SUBMISSION OF OBJECTION TO DEVELOPMENT APPLICATION 10.2020.97.1 AND  
10.2020.109.1 (STAGE 8 & 9 TALLOWOOD RIDGE ESTATE SUBDIVISION TO CREATE TWO  
LOTS OF FORTY-SEVEN (47) RESIDENTIAL LOTS

**Stage 9 Tallowood Ridge Estate 10.2020.109.1  
Subdivision to Create 47 Residential Lots. (Lot 162 DP 1251169)**

Friends of Mooibal Spur object to the latest DA at Tallowood Ridge -  
Stage 9 10.2020.109.1

### **Protection of Management Zone 8.**

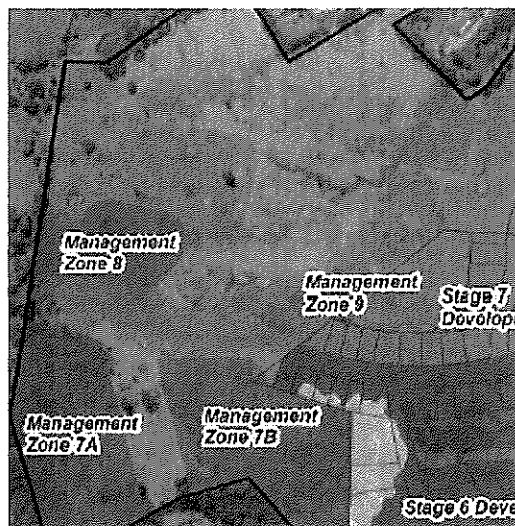
Management Zone 8 in the BCMP is for the protection of in-situ threatened flora species.

From the mapping it shows that Management Zone 8 will be severely impacted by the community title development (block C3). A transparent overlay must be produced by the developer to demonstrate the entire area of Management Zone 8 is not disturbed and has a protection buffer. The images from the DA show that Management Zone 8 will in fact have the building envelope in the vegetation. We have inferred this from the eastern bulge of the RU2 boundary (circled in red).

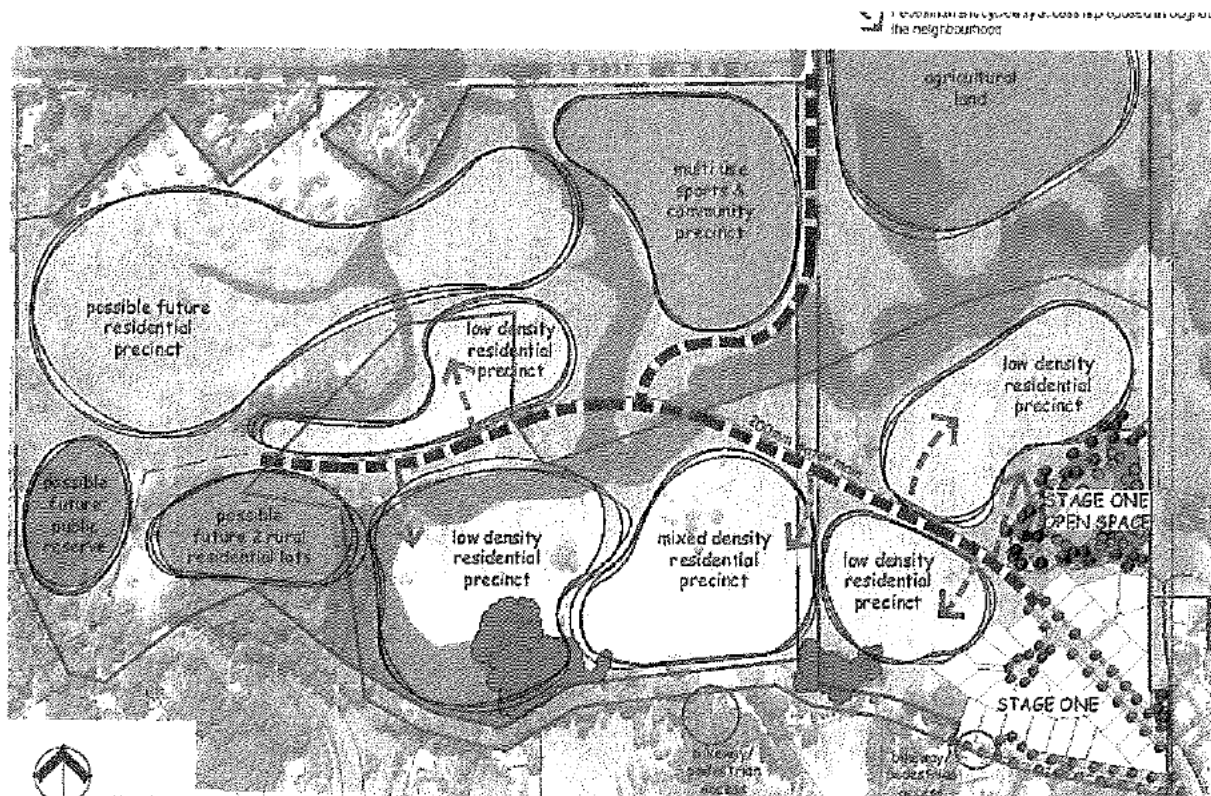
Friends of Mooibal Spur want to ensure that at a minimum the 'walking track' that is on the developers land is added to the council road reserve.

Zones 7a and 7b – must be restored (assisted natural regeneration) as part of the Stage 7 development. This is stated in the BCMP and the Court has ruled the provisions of the BCMP are to be adhered to at all times.

The developers concept proposal, as per exhibit 2.2 in the 2010 L&E court documents (below), shows "a possible future public reserve". There is no passive recreation on the site in natural areas and the community has strongly lobbied for the protection of the significant bush land and wishes to see this to be accessible to the public.
